ISSUE: Permit to Demolish/Capsulate (partial) and Certificate of Appropriateness for alterations and addition

LOCATION: Old and Historic Alexandria District
329 North Washington Street

STAFF RECOMMENDATION

Note: Staff coupled the applications for a Permit to Demolish (BAR #2021-00456) and Certificate of Appropriateness (BAR #2021-00455) for clarity and brevity. The Permit to Demolish requires a roll call vote.

Figure 3: Left: existing south elevation; note that the 3 HVAC units on roof will be relocated and screened. Right: proposed elevation showing roof deck, elevator, and fenestration changes.

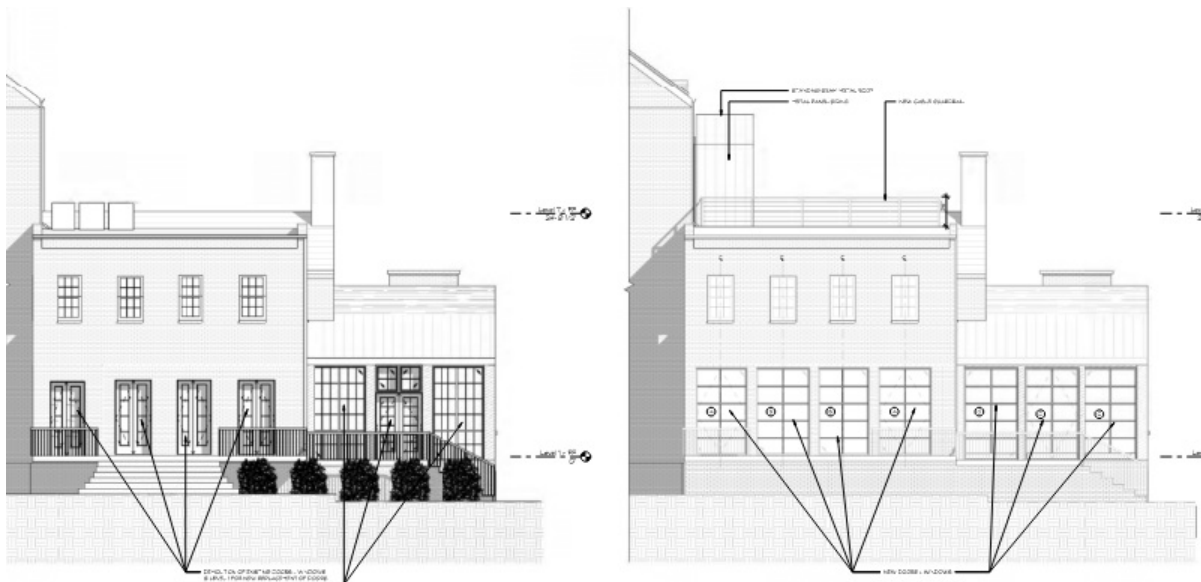
The majority of the alterations are restricted to the first floor of the post-1937 rear addition, which is not visible from a public right of way. All windows and doors here will be replaced. Other than the associated demolition to enlarge openings, staff could normally approve these changes. See Figure 3.

In addition to replacing all windows and doors on the first floor of the south elevation, the applicant proposes to replace a basement access door on the east elevation that was added in 2001. None of these are visible from a public right of way. Additionally, two existing rooftop HVAC units (see Figure 3) will be relocated to the north side of the roof deck and screened. The third unit will be removed entirely. At ground level, in the yard on the south side of the main block of the house, a third HVAC unit will be added to two existing units in this location. These are not visible from North Washington Street.

Staff recommends approval of the project as submitted, noting the recommendations of Alexandria Archaeology.
